STAFF RECOMMENDATION

521 Fatherland Street
November 19, 2018

Application: New Construction—Infill; Setback determination

Figure 10. The 1957 Sanborn map shows the house that was previously on the lot.

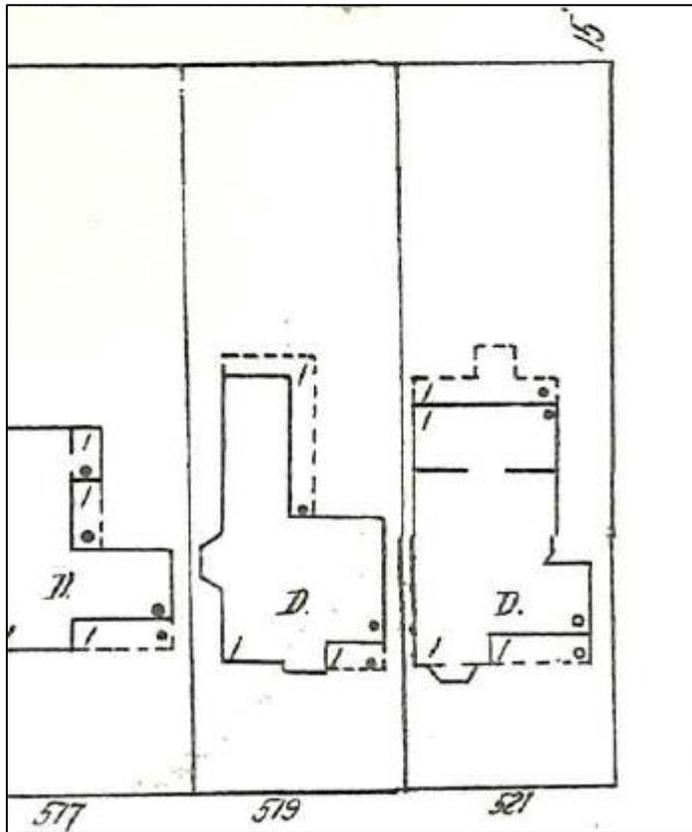
Background: 521 Fatherland Street is a vacant lot (Figure 1). The lot has been vacant since at least 1976, as the National Register nomination for the Edgefield Historic District does not list a structure on the site. The 1957 Sanborn map shows that there was previously a one-story frame house on this site (Figure 2).

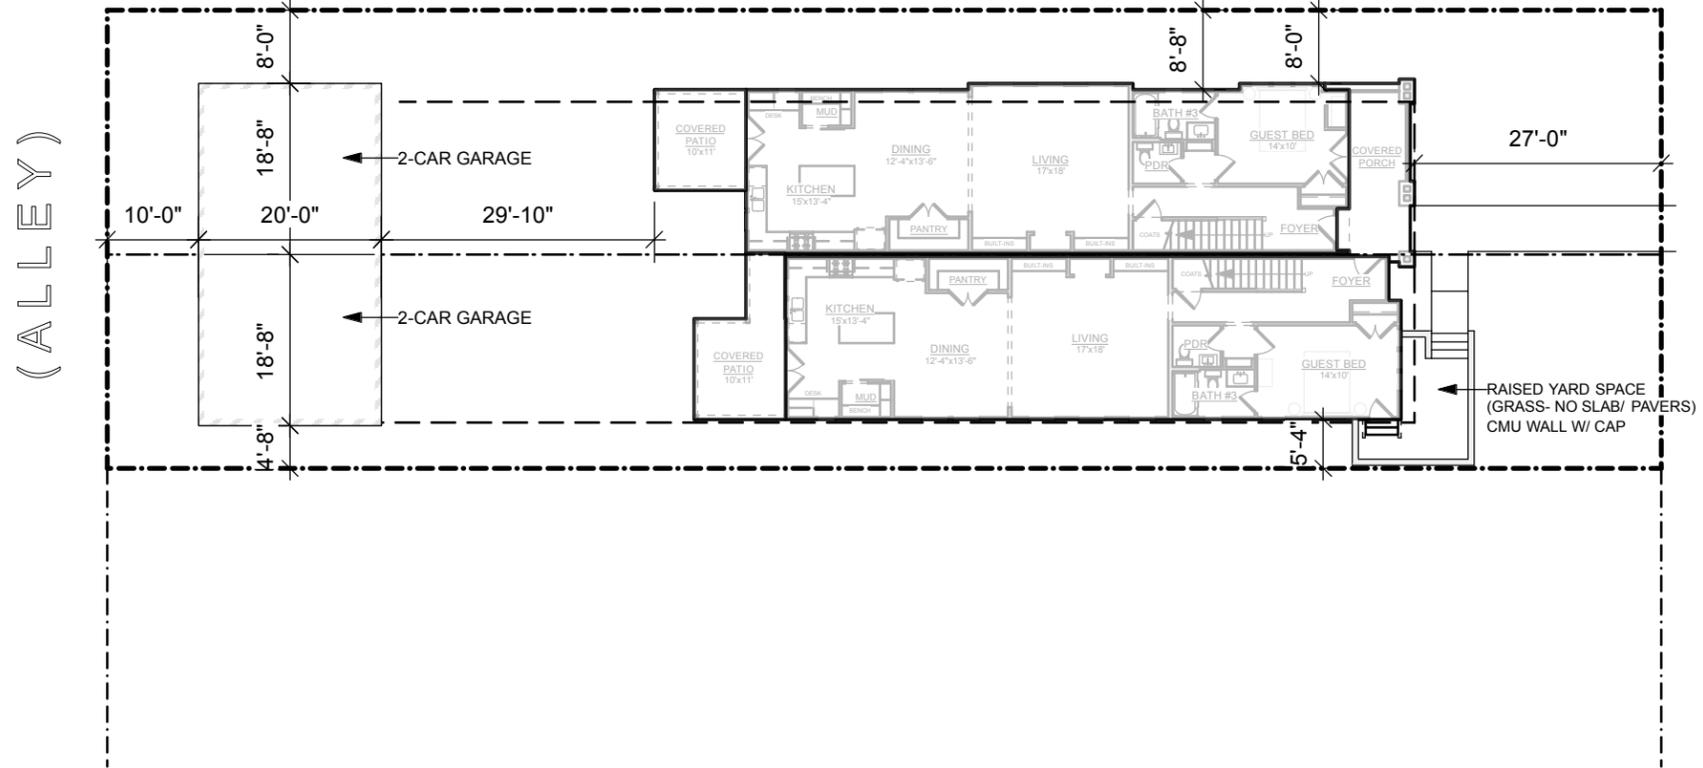
The applicant is proposing a retaining wall area at the front left corner of the house. In historic preservation zoning overlays like Edgefield, MHZC must review and approve all permanent landscape features like retaining walls. In this case, the retaining wall will create a raised yard space and will not have a slab or pavers. The retaining wall will connect to the infill at the front and side facades. The point of the raised yard is to provide access to the side entry on the left façade. There will be steps leading to the raised yard. Staff finds that where retaining walls are found, they are typically away from the house. When they are in the front yard, they are typically away from the house,

near the front and side property lines, creating an even yard height. The proposed raised yard instead creates a small raised yard area. As this is not a feature typically found in the historic Edgefield Neighborhood, staff recommends that the raised yard area be removed from the project and the side entry be accessed via stairs.

4. The HVAC be located behind the house or on either side, beyond the mid-point of the house;
5. The applicant remove the raised yard area on the front façade and instead provide stair access to the left façade side entry; and,

FRONT (STREET) ELEVATION

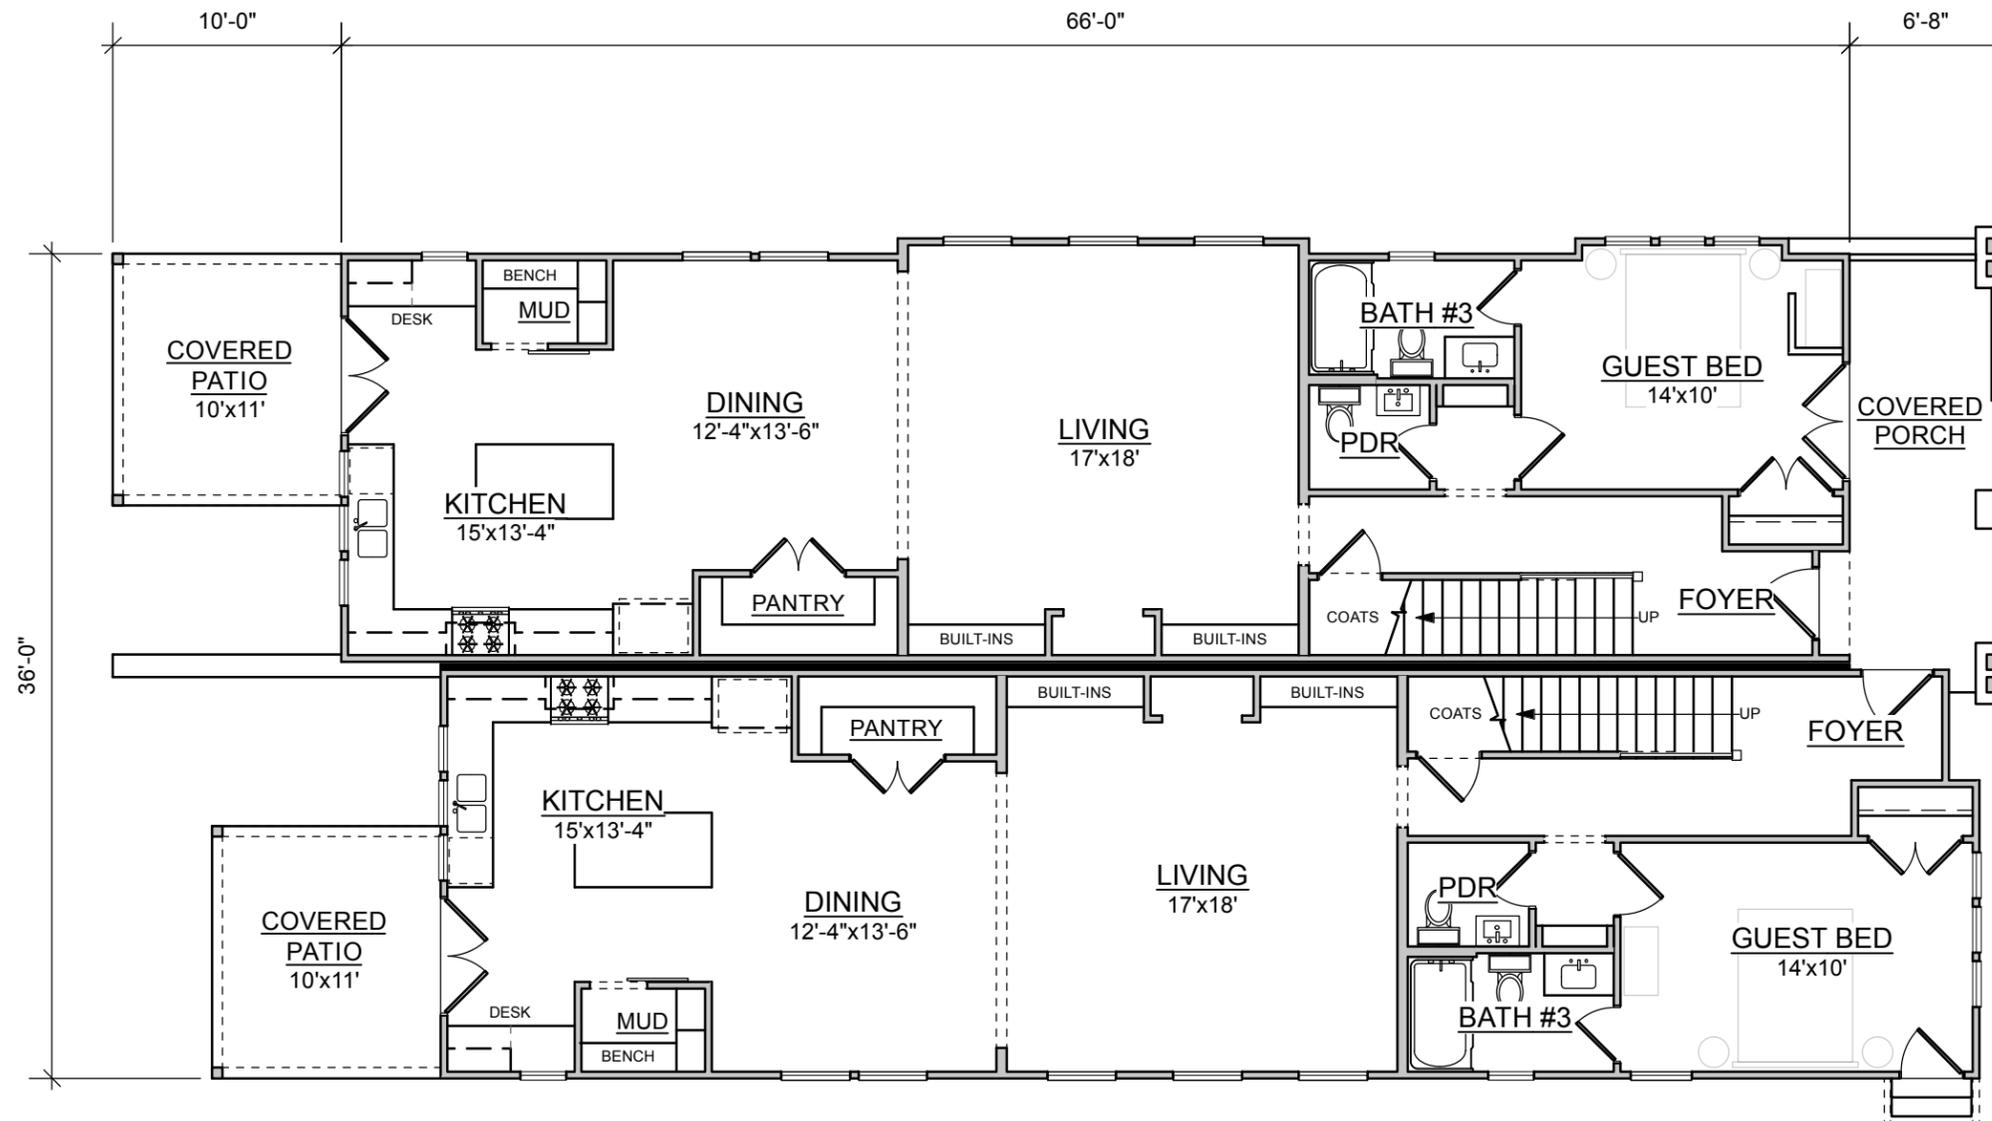
Roof form & Building Shape: The infill will have a gabled-ell form, which is appropriate for the Edgefield Historic Preservation Zoning Overlay. The front-facing gable will have a 7/12 pitch. On the side façades, the main two-story gables will have a 6/12 pitch. The one-story bays on the South 6th Street façade will have a 5/12 pitch. The gables on the rear facades will have 4/12 pitches. Staff finds the infill's roof form and building shape are compatible with the historic context and meet Sections III.B.2.c and III.B.2.d. of the design guidelines.

Orientation: The infill will be oriented towards Fatherland Street, which is appropriate. The front door to the right residential unit will be on the front façade, behind a partial width front porch that is six feet, eight inches (6'8") deep. French doors will also be behind the front porch. The entry to the left residential unit will also be accessed via the front porch, but this door will be on the side of the gabled-ell. Staff finds that this door, which does not face Fatherland Street, is appropriate because secondary and additional doors were commonly found on the side like this. The left unit also has a secondary entrance on the left façade, just behind the front left corner of the house. This entry will have a bracketed stoop cover over the door. It will read as a secondary entrance.

Proportion and Rhythm of Openings: The windows on the proposed infill are all generally twice as tall as they are wide, thereby meeting the historic proportions of openings. There are no large expanses of wall space without a window or door opening. Staff finds the project's proportion and rhythm of openings to meet Section III.B.2.f. of the design guidelines.
